Former Homebase, Manor Road, Richmond

Response to Stage 1 Decision Flood Risk, Water and Drainage

REPORT REFERENCE: 126782-FHT-ZZ-XX-RP-C-0002

Drawing No.: **126782-C-4000** Revision: **P05**

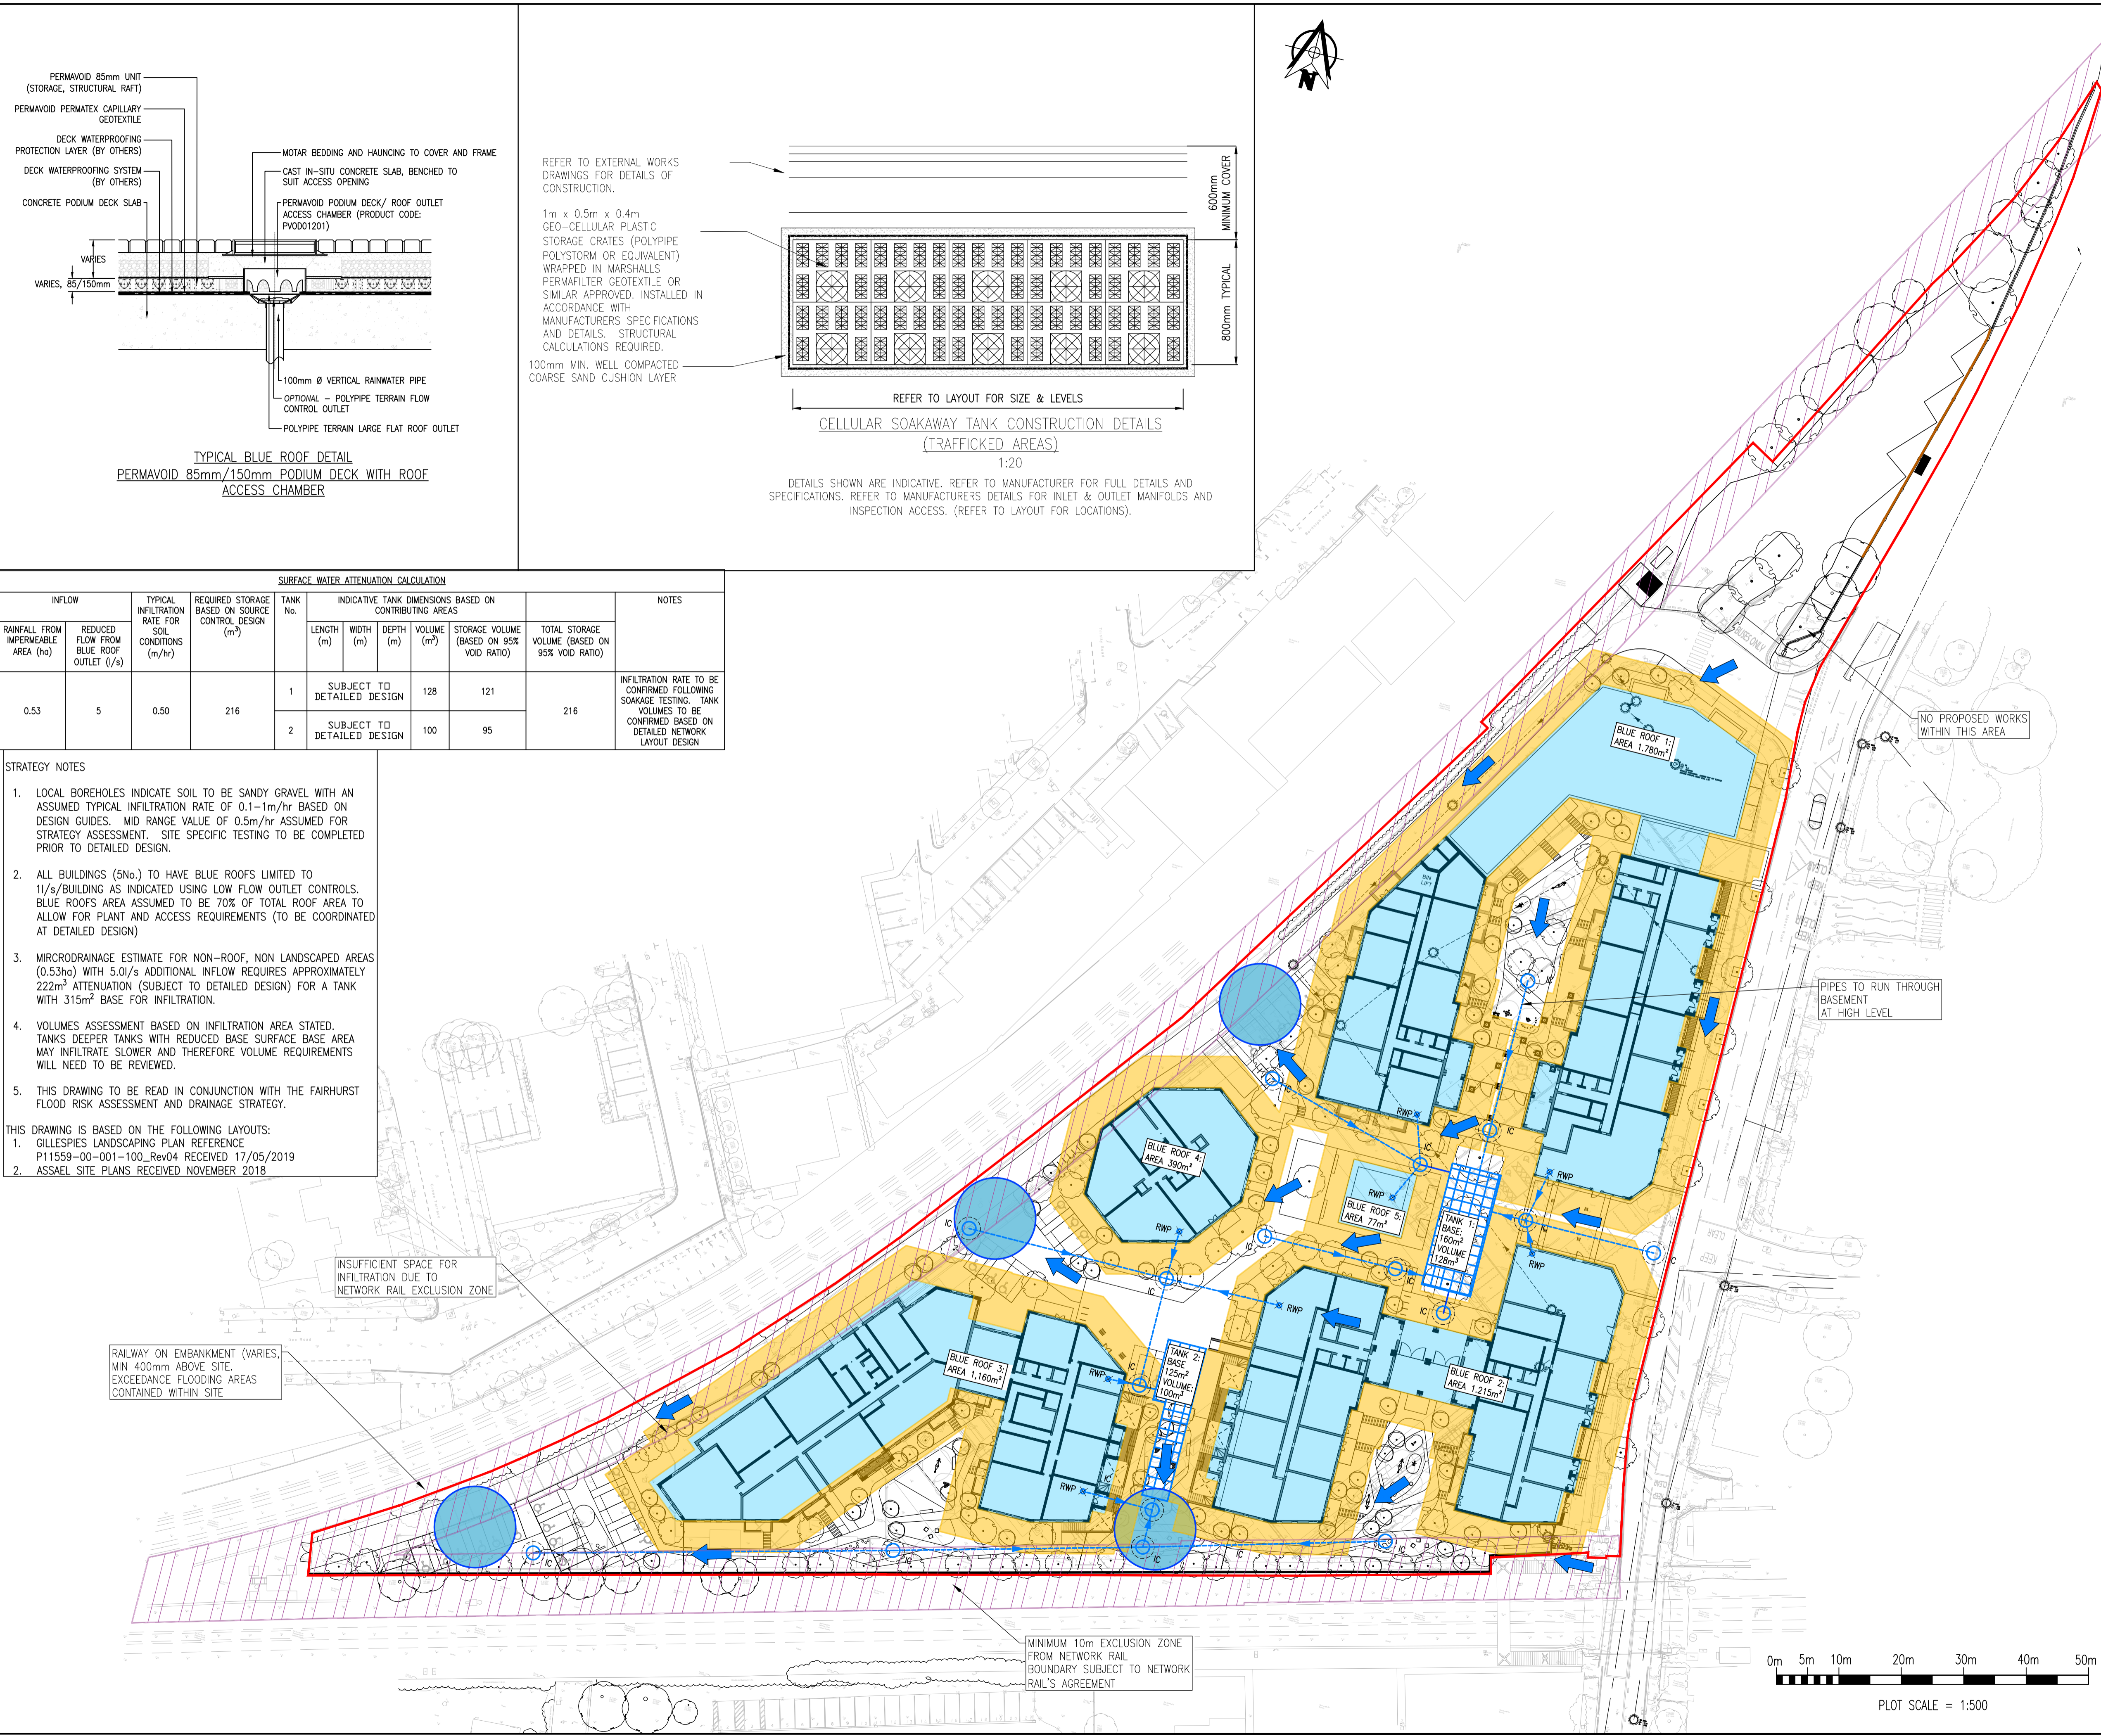
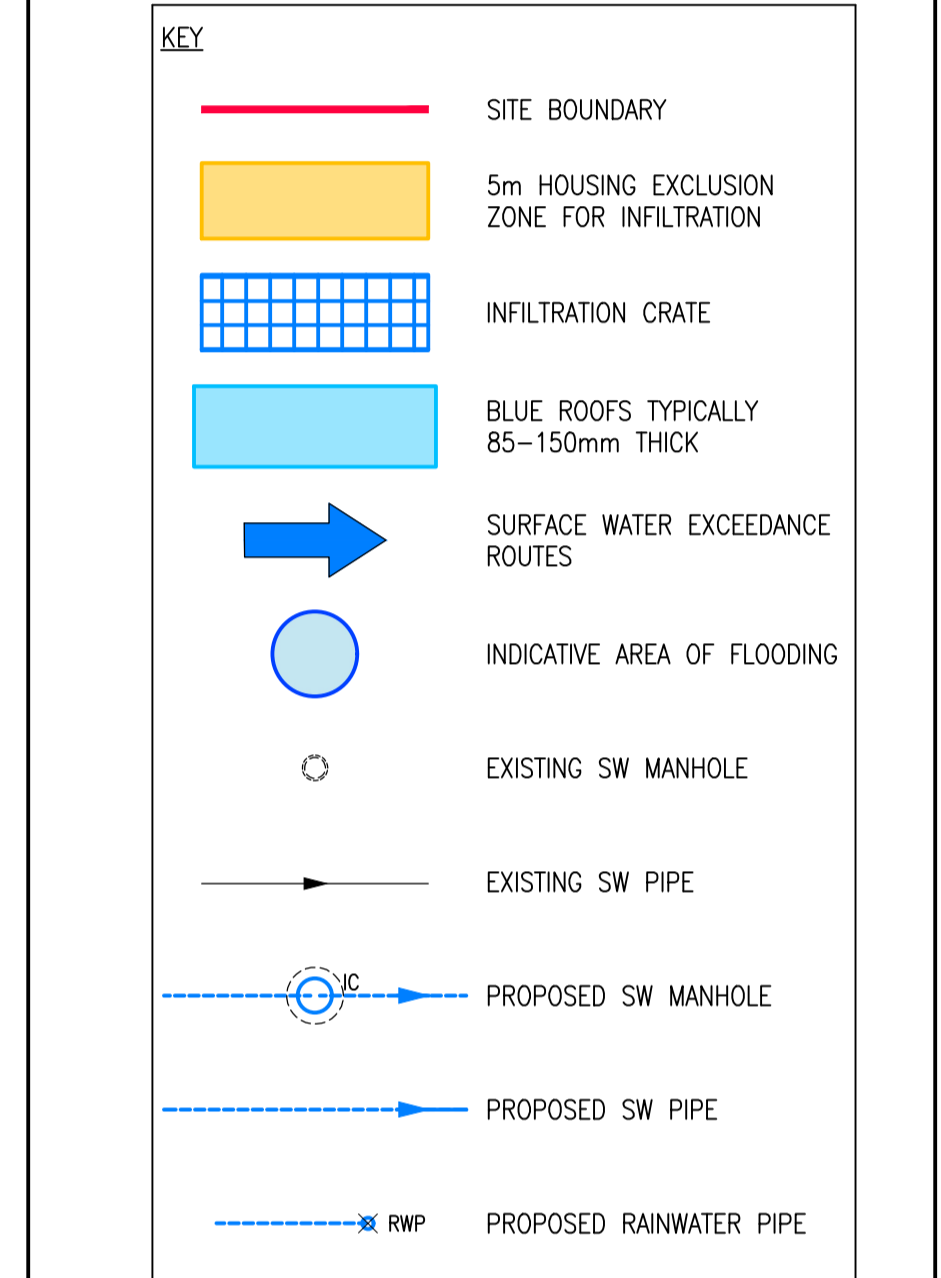
59 The surface water drainage strategy for the proposed development does not comply with London Plan policy 5.13 and draft policy S113. The applicant should provide revised additional attenuation storage volume calculations, and exceedance assessment.

8. No assessment of exceedance flow paths has been provided. Additional information should be provided showing that exceedance flow paths through the site are available in the case of attenuation system blockage or an extreme rainfall event.

- 2.2.4 Section 7.1 has been added to the FRA which covers mitigation against the risk of flooding by groundwater through limiting the run-off from blue roofs to 1 l/s per building and provision of an exceedance flow path through the site which routes water resulting from groundwater flooding away from the buildings and road adjacent to the site and into areas where any flooding which occurs would leave a safe route

of exit for residents. This is shown on Fairhurst drawing 126782-C-4000 which is included as an Appendix to this document as well as to the FRA.

- 2.2.12 Fairhurst drawing 126782-C-4000 (provided in Appendix A2 of this Technical Note and A6 of the FRA) shows the updated strategy layout including exceedance routes.

3.2.8 Refer to Fairhurst Drawing 126782-C-4000 included as an appendix to this Technical Note which has been updated to include exceedance flow routes. It should be noted the drainage network is designed to have sufficient capacity to fully contain all storms up to and including the 100yr + climate change storm. These routes are for any storms more severe than this only.

- MICRODRAINAGE ESTIMATE FOR NON-ROOF, NON LANDSCAPED AREAS (0.53ha) WITH 5.0l/s ADDITIONAL INFLOW REQUIRES APPROXIMATELY 222m³ ATTENUATION (SUBJECT TO DETAILED DESIGN) FOR A TANK WITH 315m² BASE FOR INFILTRATION.
